SUBJECT: Lake Pontchartrain, La. and Vicinity, Florida Avenue Complex

TO C/Engineering Div

FROM A/E, New Orleans

Lake Pontchartrain, Louisiana and Vicinity
Florida Avenue Complex

BYPASS CHANNEL WEST IHNC

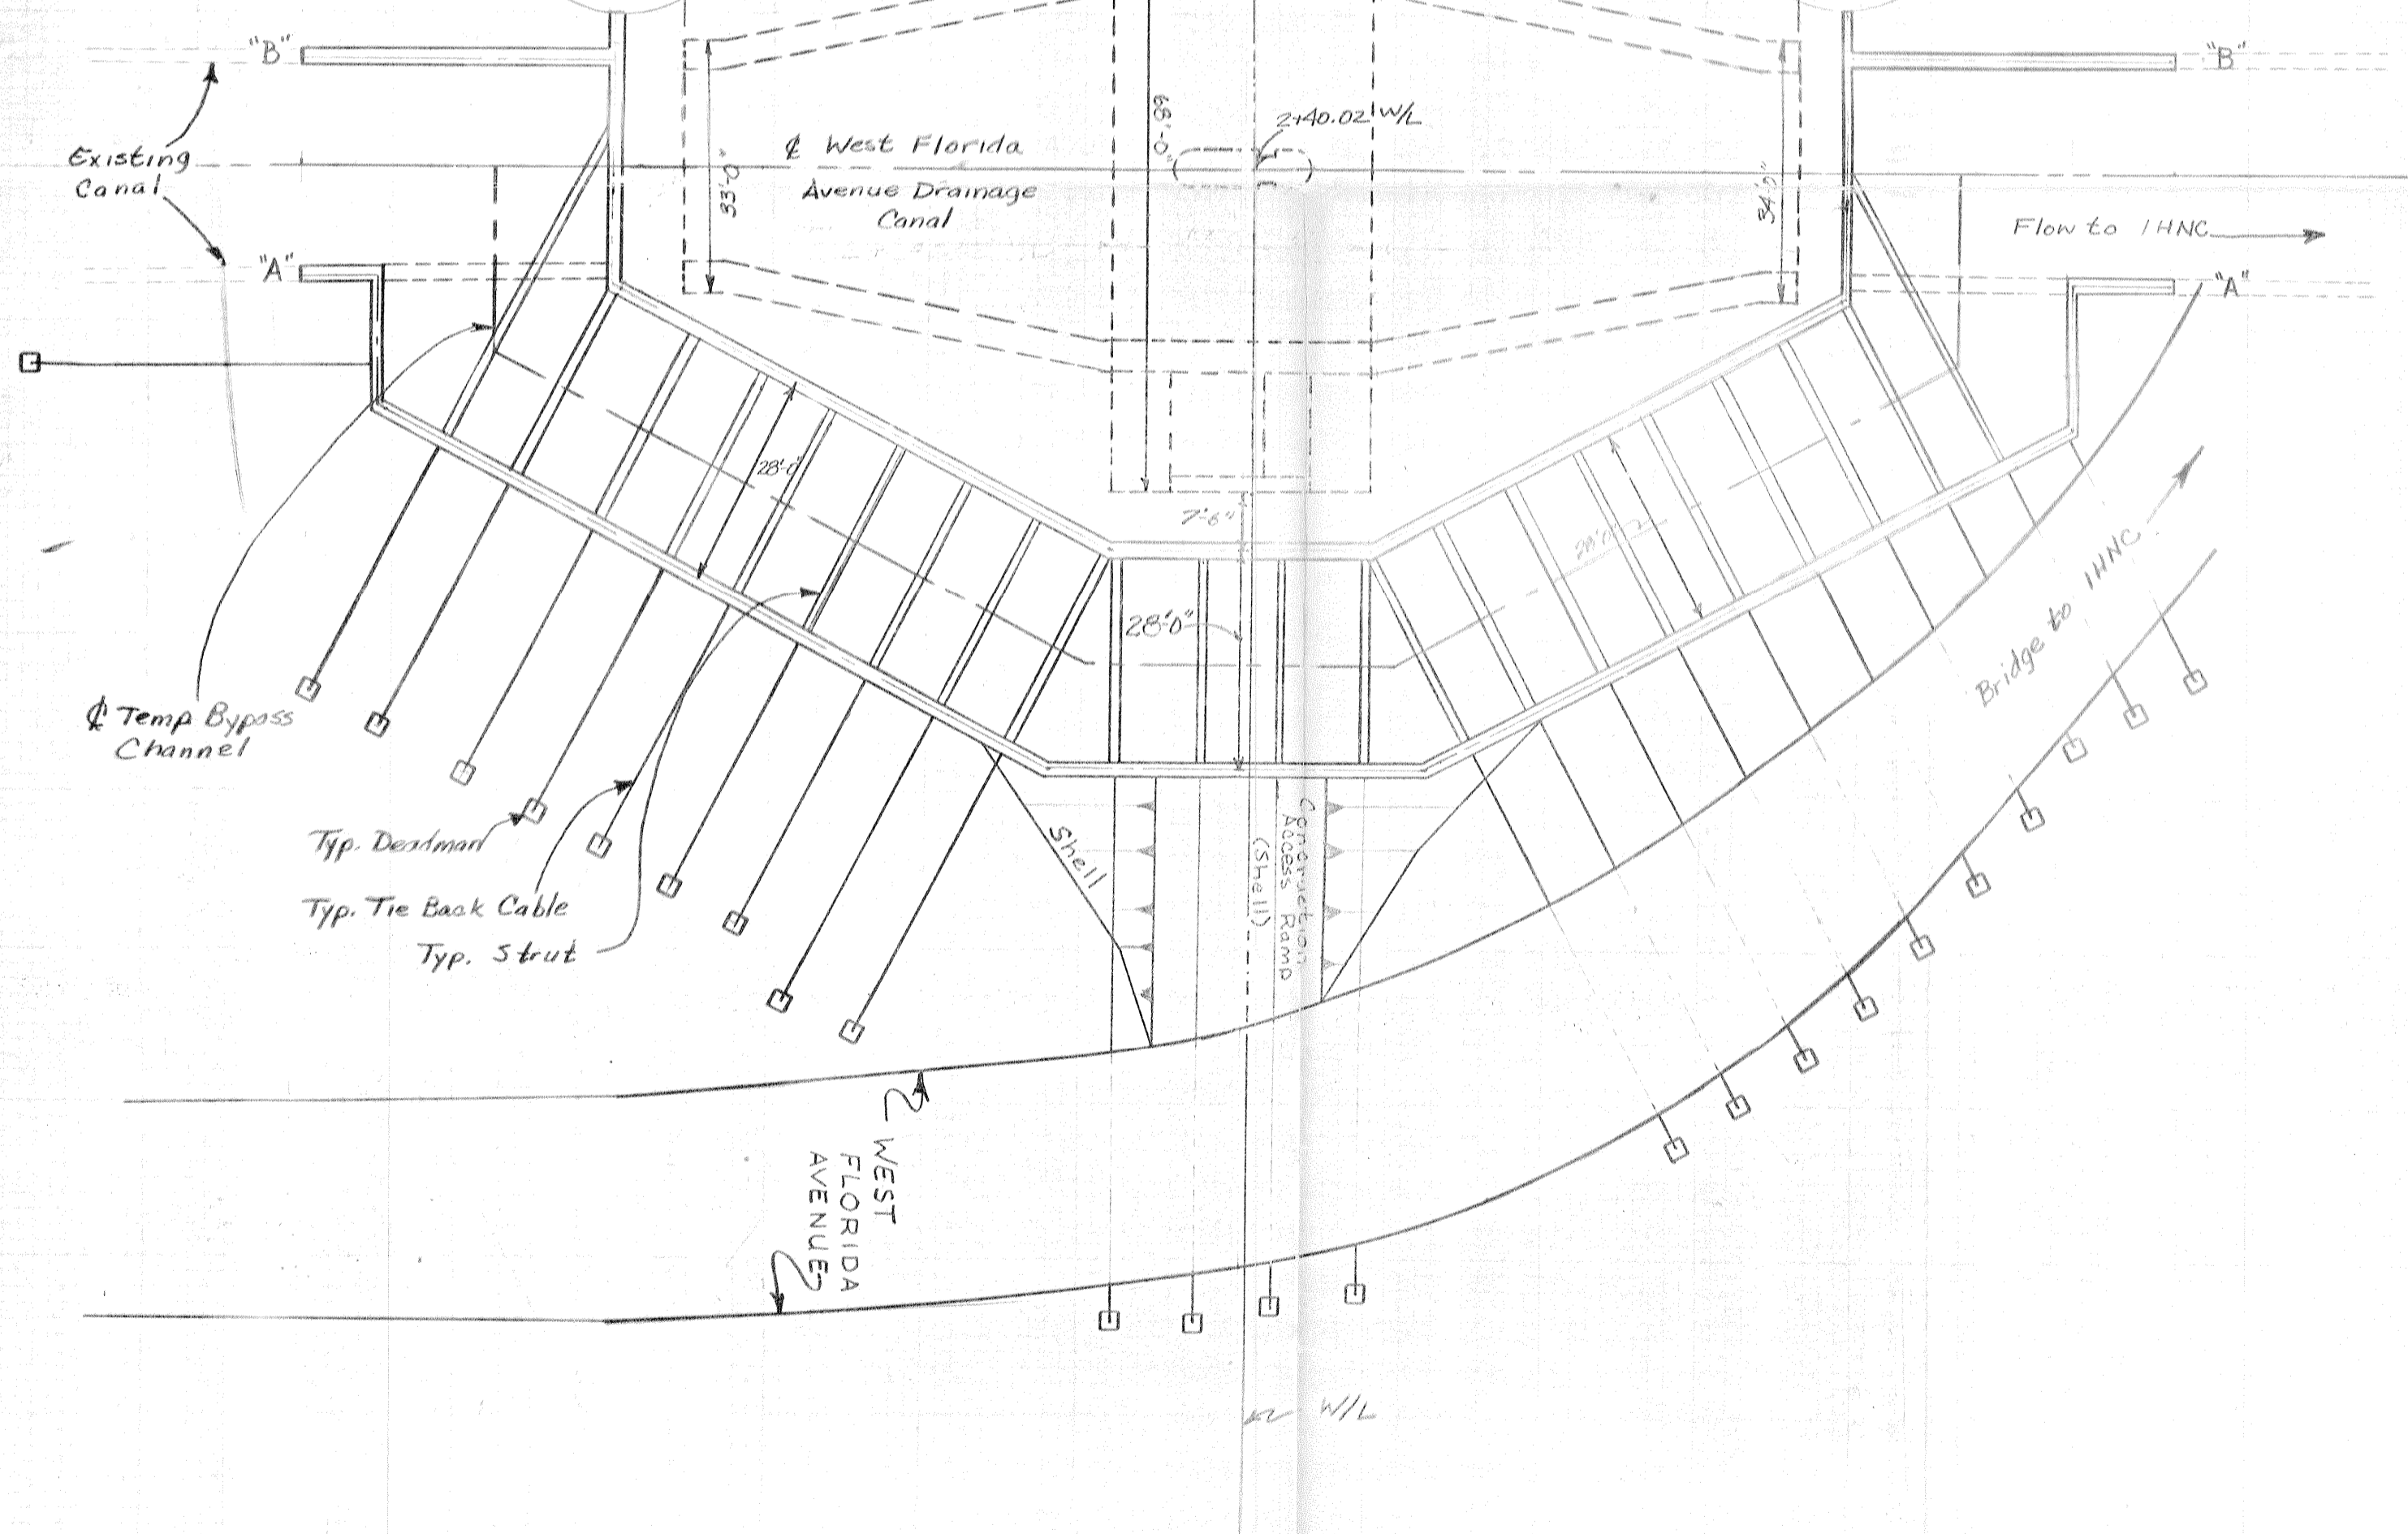
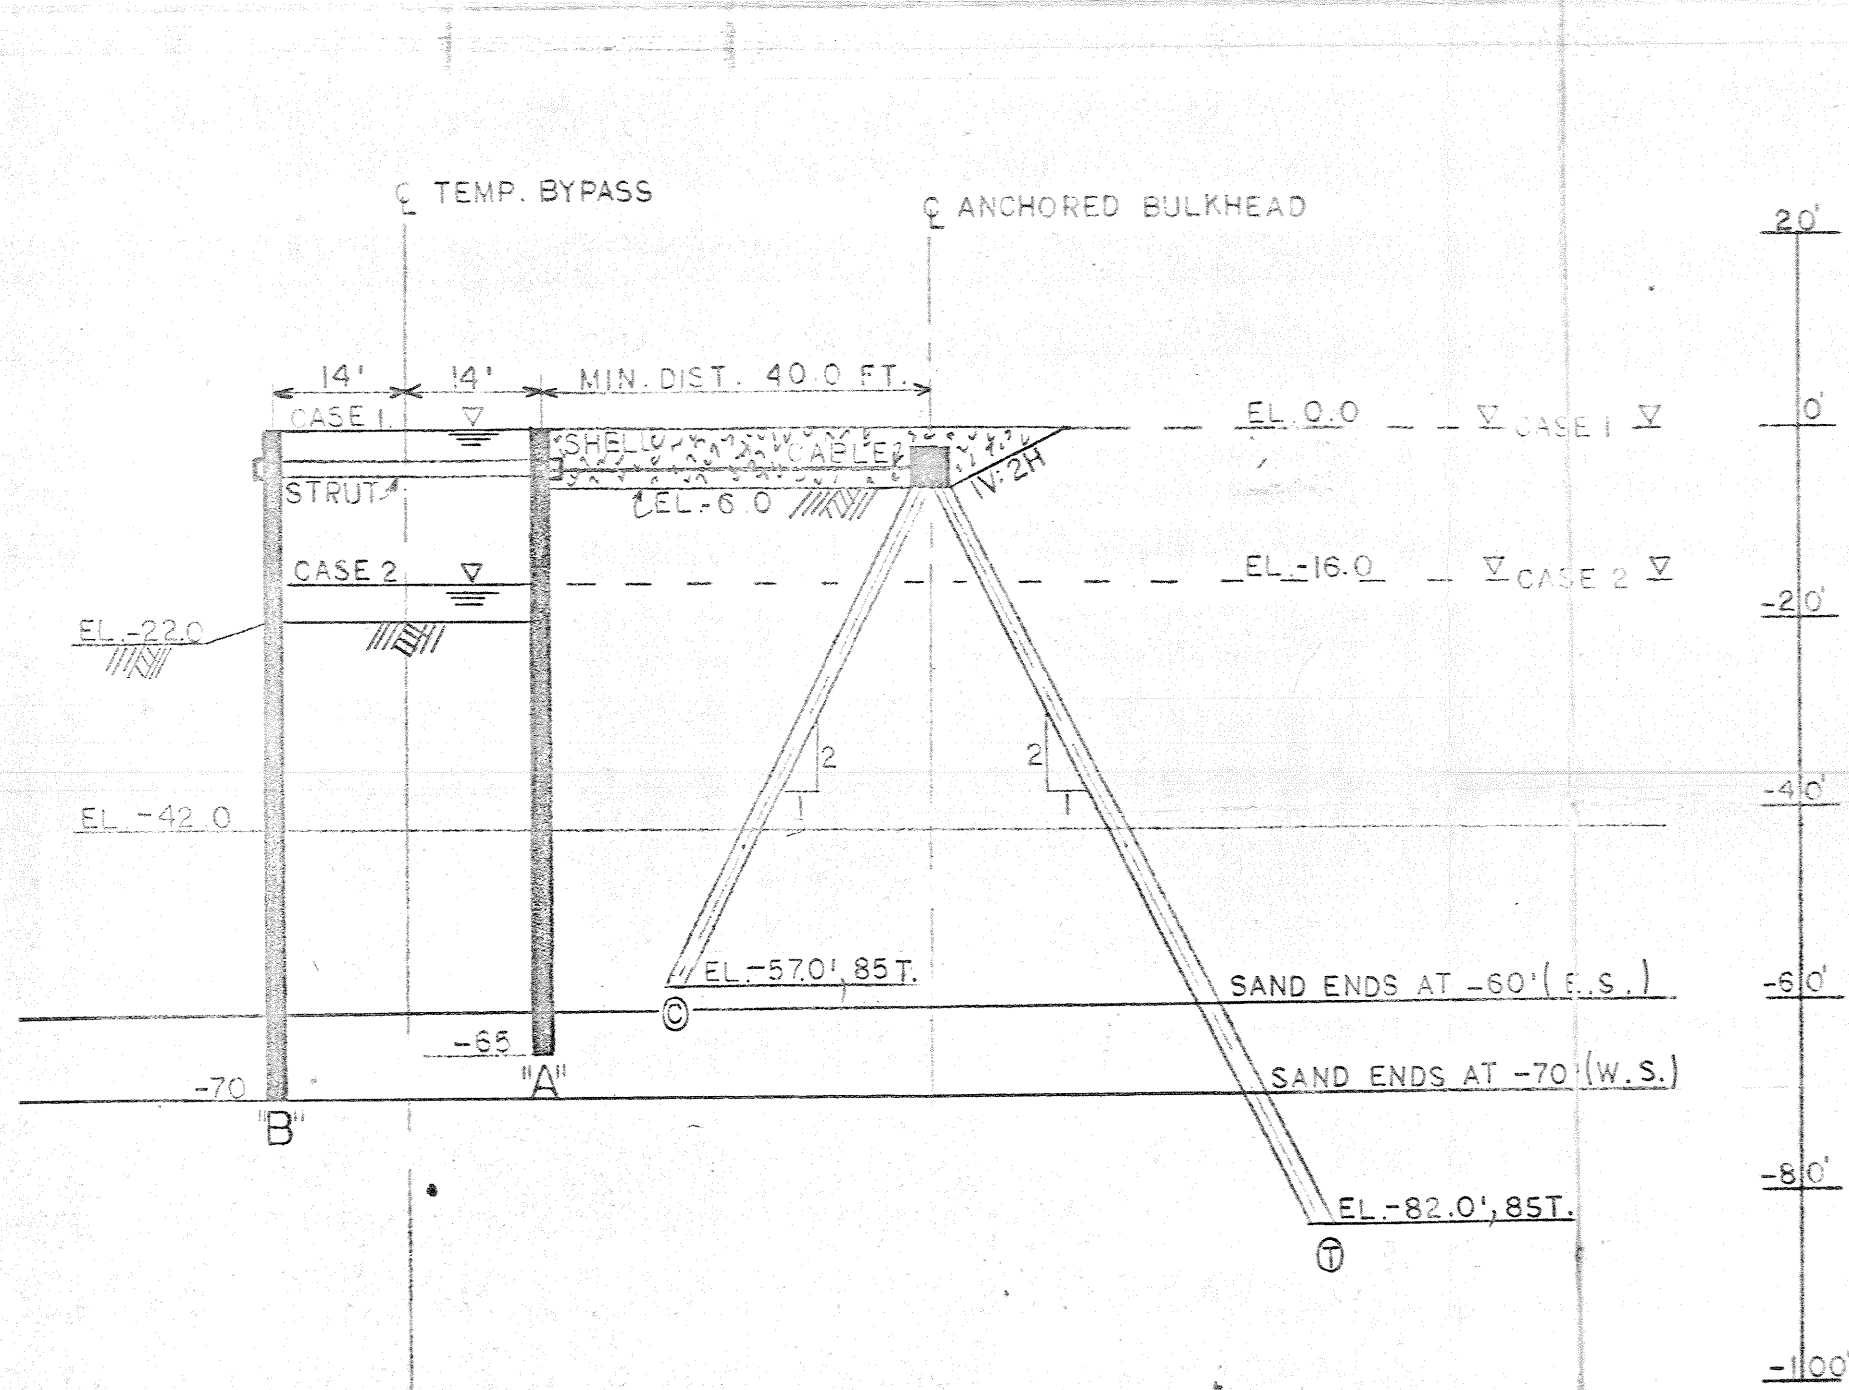
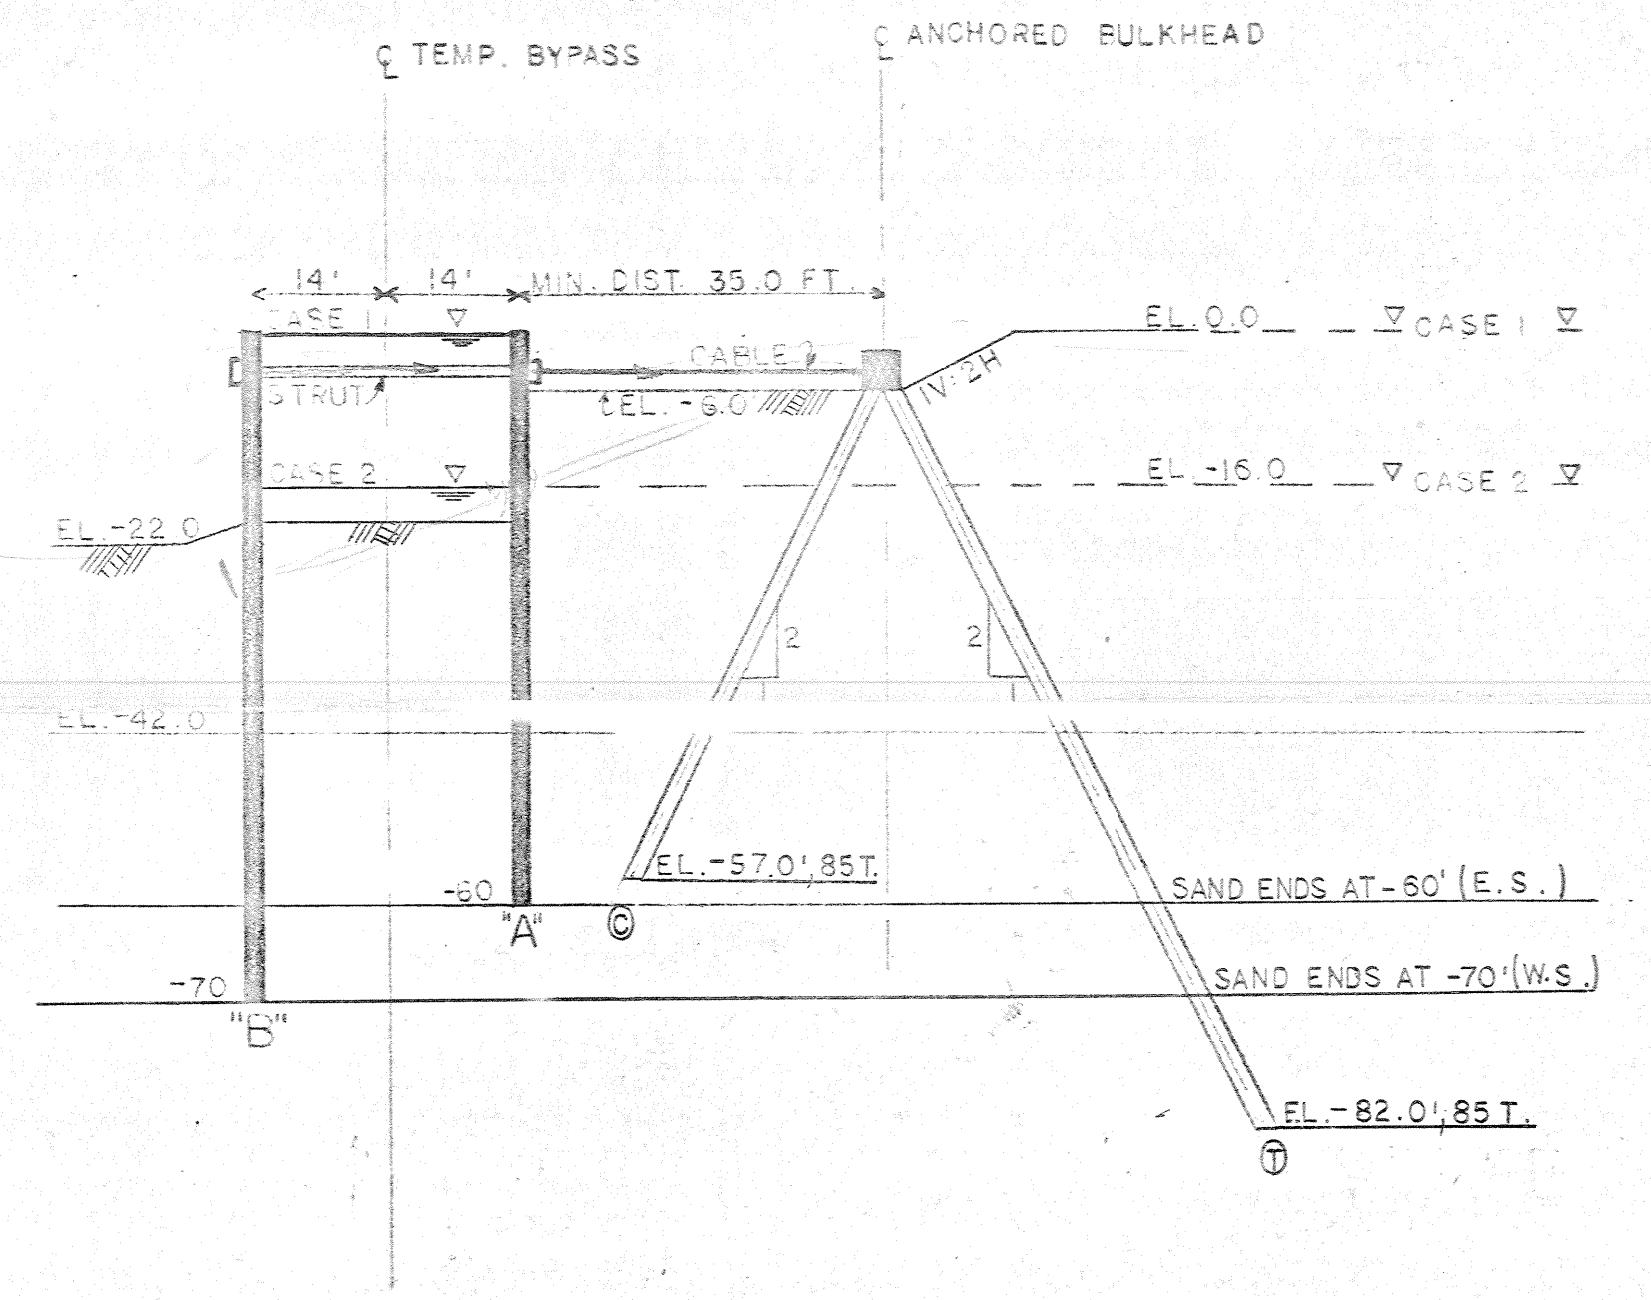
(1) Installation of deadmen and tieback cables in the vicinity of west Florida Avenue is not seen as a major construction problem. Traffic can be diverted on to east Florida Avenue during installation.

(2) Recommend a rough connection to the bridge side channel instead of a water tight connection. The sheet pile wall will keep the excavation dry and flooding outside the cofferdam will not affect construction.

(4) The major construction problem with the bypass is restriction of the working area. Natural access to the worksite is from west Florida Avenue. The bypass channel is too wide to allow a crane to reach the structure from the south side unless an extremely large crane is used. Therefore, a contractor will probably work from the cellular cofferdam on the north side of the excavation. Access to this area must come across the railroad tracks. The railroad embankment appears 6 or 7 feet above natural ground and will require an extensive embankment for an access road crossing.

(1) Installation of deadmen and tieback cables in the vicinity of west Florida Avenue is not seen as a major construction problem. Traffic can be diverted on to east Florida Avenue during installation.

(2) Recommend a rough connection to the bridge side channel instead of a water tight connection. The sheet pile wall will keep the excavation dry and flooding outside the cofferdam will not affect construction.

(4) The major construction problem with the bypass is restriction of the working area. Natural access to the worksite is from west Florida Avenue. The bypass channel is too wide to allow a crane to reach the structure from the south side unless an extremely large crane is used. Therefore, a contractor will probably work from the cellular cofferdam on the north side of the excavation. Access to this area must come across the railroad tracks. The railroad embankment appears 6 or 7 feet above natural ground and will require an extensive embankment for an access road crossing.
